CITY COUNCIL AGENDA ITEM COVER MEMO

Resolution authorizing the Mayor to enter into an agreement with the low bidder, Angelo Iafrate Construction Company, for Veterans Drive Extension, Project No. 65-11-RD02

Document Name: **Angelo Iafrate-Veterans Drive-Project No. 65-11-RD02**

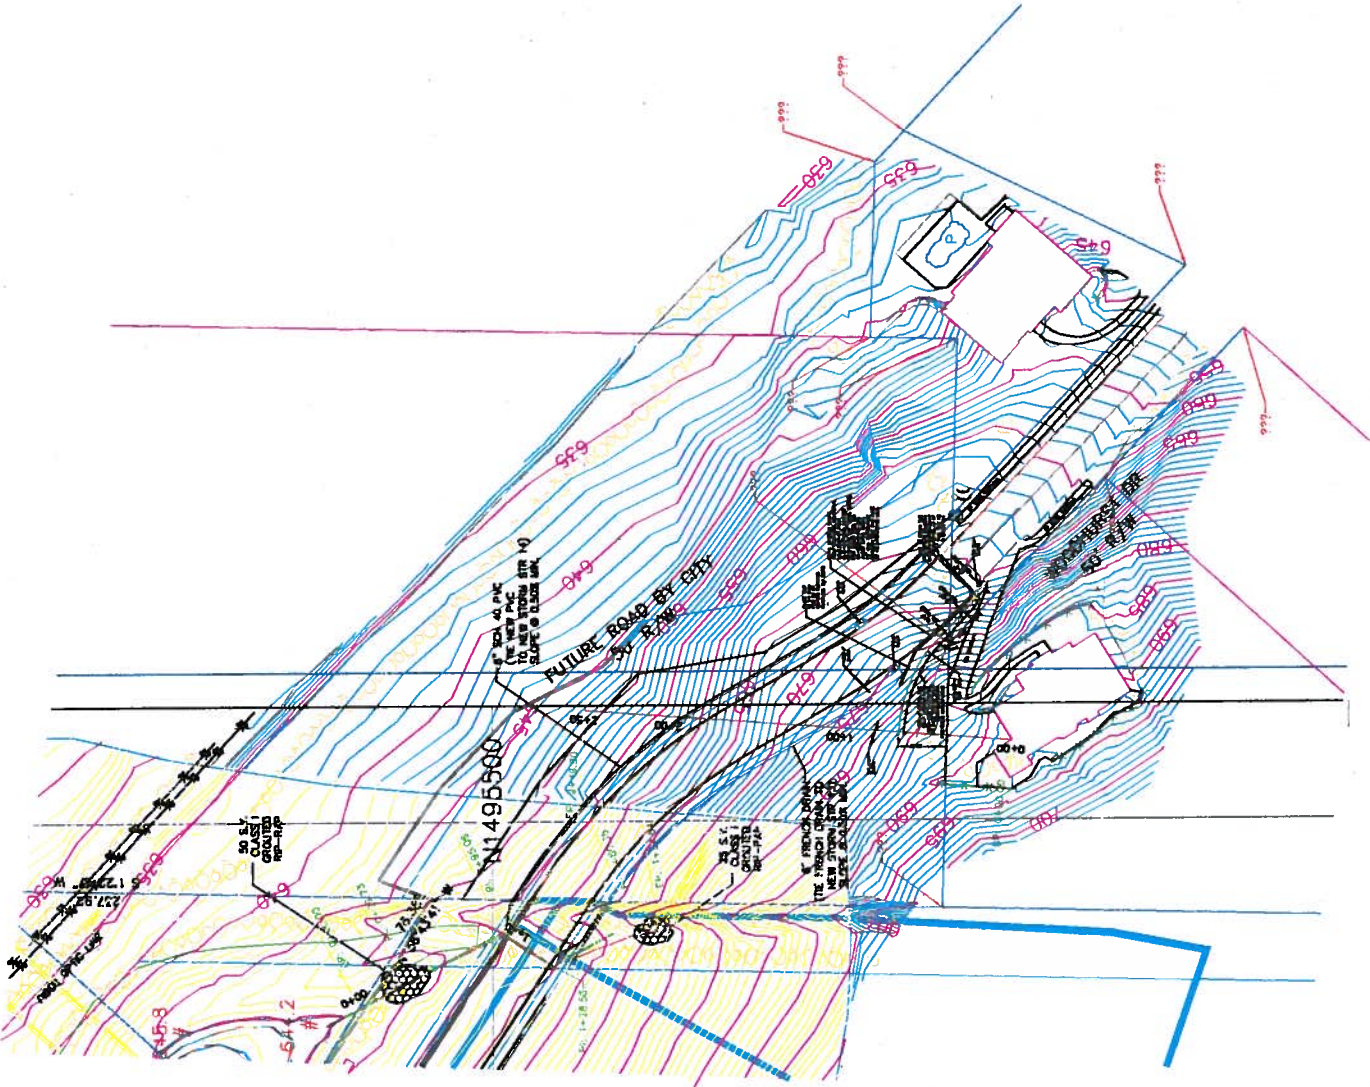
Q: With it being a lump sum in price, Contractors need to know exactly what work will be done.

A: The only work that will be done is from Station 11+22.63 to the end of the construction. If you look on Sheet 5 of the plans, in the upper right hand corner where it says "Future Road by City" that is the project. Everything before that has been built. Contractors may want to drive out to the site and look at the condition of the road so they can see what is there.
